DART AEROSPACE LTD	Work Order:	108684
Description: Crosstube Assembly, Mid Fwd	Part Number:	D206-667-147
Inspection Dwg: D206-667-147 Rev: A		Page 1 of 2

DART AEROSPACE LTD HAWKESBURY, ONTARIO, CANADA	
DRAWING NO. D206-667-147	REV. A SHEET 1 OF 4
TITLE CROSSTUBE ASS'Y (206L MID FWD)	SCALE NTS
COPYRIGHT © 2010 BY DART AEROSPACE LTD THIS DOCUMENT IS PRIVATE AND CONFIDENTIAL AND IS SUPPLIED ON THE EXPRESS UNDERSTANDING THAT IT IS NOT TO BE USED FOR ANY PURPOSE OR COPIED OR COMMUNICATED TO ANY OTHER PERSON WITHOUT WRITTEN PERMISSION FROM DART AEROSPACE LTD.

DRAWING NO. D206-667-147	TITLE CROSSTUBE ASS'Y (206L MID FWD)	REV. A	DART AEROSPACE LTD ENGINEERING ORDER		D.E.O. NO. D206-667-147-A-1	SHEET NO. SHEET 1 OF 1	SCALE NTS
DRAWN qp	CHECKED ADS	MFG. APPR. [Signature]	APPROVED [Signature]		DE APPR. [Signature]		
DATE 11.07.15	DATE 11.07.20	DATE 11.07.21	DATE 11.07.21		DATE 11.07.21

DRAWING NO. D206-667-147	TITLE CROSSTUBE ASS'Y (206L MID FWD)	REV. A	DART AEROSPACE LTD ENGINEERING ORDER		D.E.O. NO. D206-667-147-A-2	SHEET NO. SHEET 1 OF 1	SCALE NTS
DRAWN AJS	CHECKED	MFG. APPR.	APPROVED	DE APPR.			
DATE 12.08.02	DATE 12.08.02	DATE 12.08.02	DATE 12.08.02	DATE 12.08.02	DATE 12.08.02

DETAIL P
 BONDING STRAP INSTALLATION 2 PL

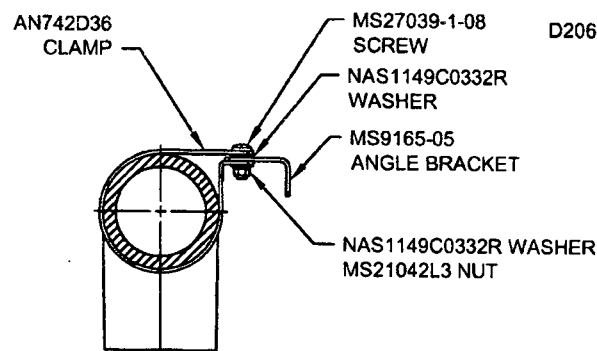
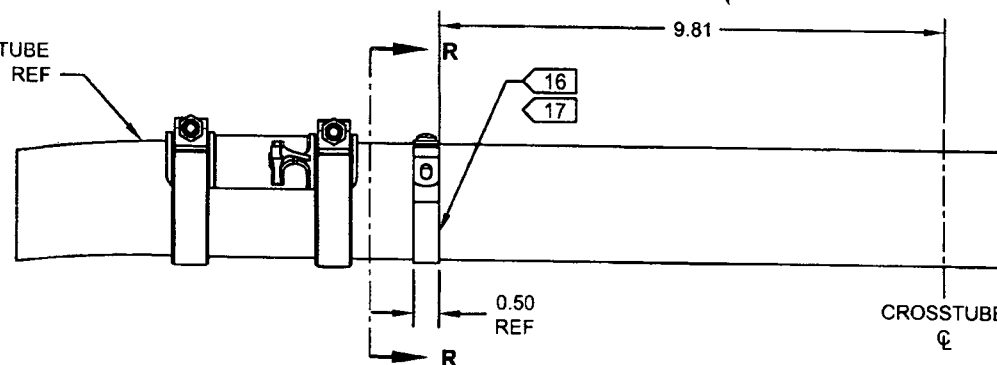
PURPOSE:

ADD ELECTRICAL GROUNDING STRAP

- 16) MASK AREA UNDER CLAMP PRIOR TO PAINTING
 17) SEAL EDGES WHERE AN742D36 CLAMP MEETS WITH THE CROSSTUBE USING SIKAFLEX-241/-291 OR MIL-S-8802 CLASS B2 OR PROSEAL 890 SEALANT
 18) PERFORM RESISTANCE CHECK TO ENSURE MAX RESISTANCE IS 10 MILLIOHMS

ITEM	QTY -147	PART NUMBER	DESCRIPTION
1	X	D206-667-147	CROSSTUBE ASSEMBLY (206L MID FWD)
10	2	AN742D36	CLAMP
11	2	MS9165-05	ANGLE BRACKET
12	2	MS21042L3	NUT (OR MS21042-3)
13	2	MS27039-1-08	SCREW
14	4	NAS1149C0332R	WASHER (OR AN960C10L)
